ALERT SERVICE BULLETIN

204B-15-69

MODEL AFFECTED: 204B

SUBJECT: MAIN ROTOR BLADE BOLT 204-011-151-001
INSPECTION, REWORK AND REPLACEMENT OF

Figure 1. Main Rotor Blade Bolt Inspection and Rework

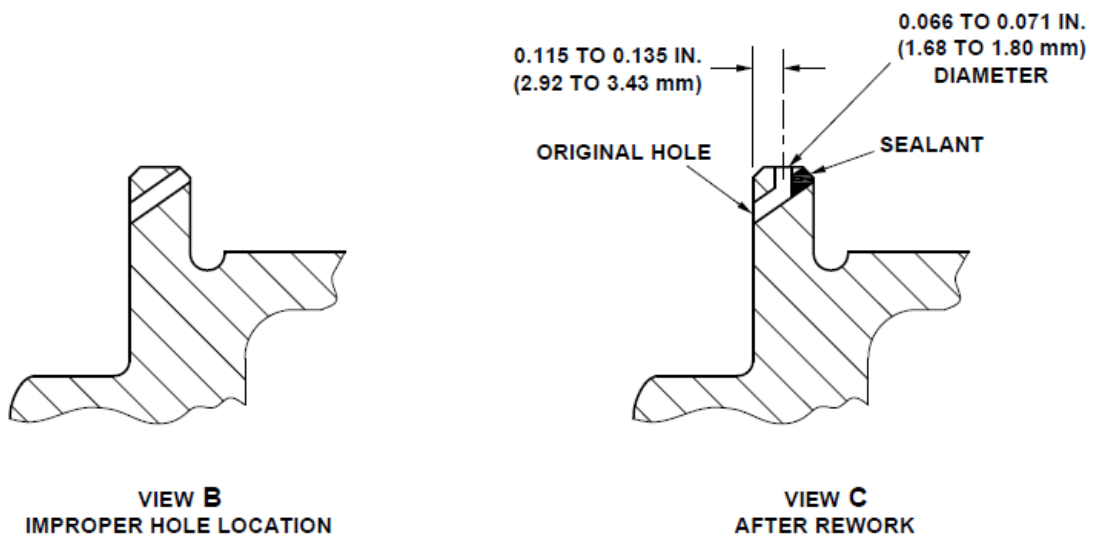
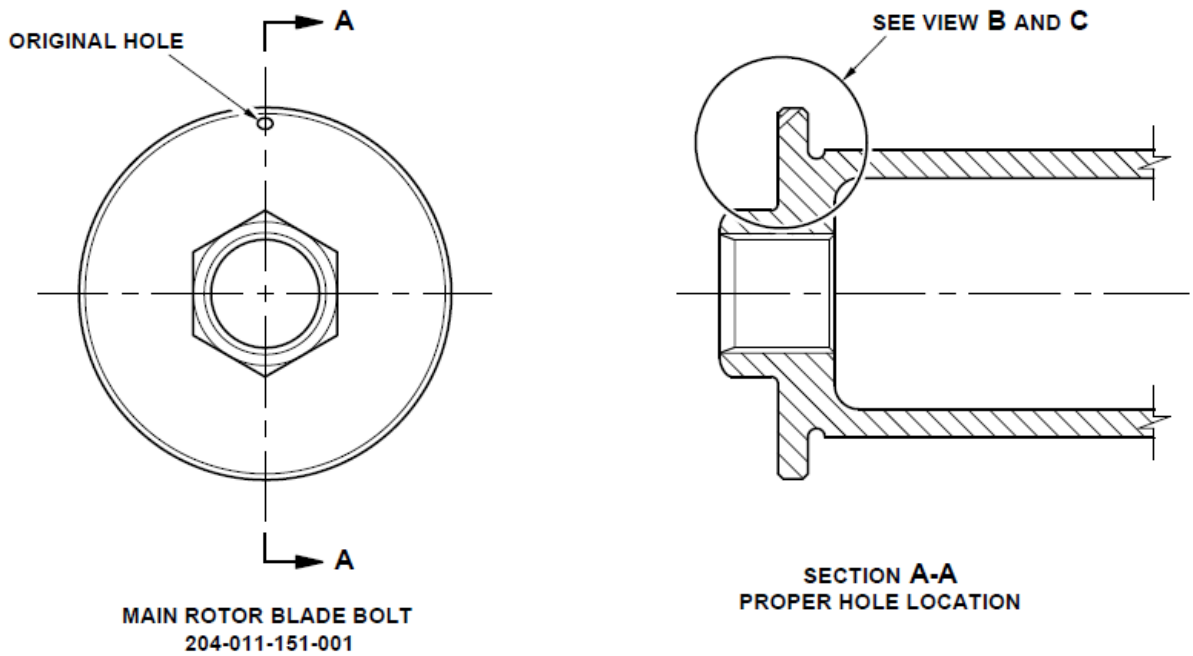
Main rotor blade bolts listed in Table 1 of the Accomplishment Instructions are suspected to have the lockwire hole for the lead weight plug incorrectly drilled. This non-conformity may prevent installation of the lockwire and lead to incorrect installation of the blade bolt. This bulletin mandates a one-time inspection for conformity of the affected blade bolts listed in Table 1 and provides rework instructions allowing the use of these blade bolts. After rework, affected blade bolts will require a repetitive 300 flight hours inspection of the reworked area. As a terminating action to this repetitive inspection, the reworked blade bolts will require replacement. As an alternative option to the rework, defective blade bolts that have not been installed and/or reworked can be returned to Bell Helicopter as "new part return" and a credit will be offered. Applicability of this bulletin to any spare part shall be determined prior to its installation on an affected helicopter.

1. Verify if any of the blade bolts listed in Table 1 are installed on a helicopter or in spare stock. If none of the blade bolts listed in Table 1 are found installed or in spares stock, go to step 3.
2. Blade bolts listed in Table 1 that have the safety wire hole drilled as shown in Figure 1, Section A-A, conform to the approved engineering. Go to step 3.
3. Make an entry in the helicopter logbook and historical service records indicating findings and compliance with this Alert Service Bulletin.
4. Blade bolts listed in Table 1 that have the safety wire hole drilled incorrectly as shown in Detail B, can either be returned to Bell Helicopter as “new part return”, or reworked as follows:

- a. Radially mark the location of the existing lockwire hole on the flange with a marker (Figure 1).
- b. Drill a 0.066 to 0.071 inch (1.68 to 1.80 mm) diameter hole in the center of the flange, as shown, to break into the existing safety wire hole.

- c. Break edges 0.0005 to 0.015 inch (0.013 to 0.38 mm) radius or 0.0005 to 0.015 inch (0.013 to 0.38 mm) x 40-50°.
- d. Verify the intersection of the two bolt holes with a 10X magnifying glass to ensure it is free of burrs or knife edges and that the opposing hole has no damage.
- e. Insert a piece of safety wire in the new hole that exits the upper surface of the flange and fill the lower end of the original safety wire hole with sealant (C-251). Make sure the sealant is flush with the end of the hole and the flange.
- f. Remove the piece of safety wire prior to sealant curing. Once the sealant has cured, fill and drain the new safety wire hole with primer (C-204).
- g. Reidentify the part number on the blade bolt assembly by adding the letter "R" after the last three digits using a permanent marker (i.e., 204-011-151-001R).
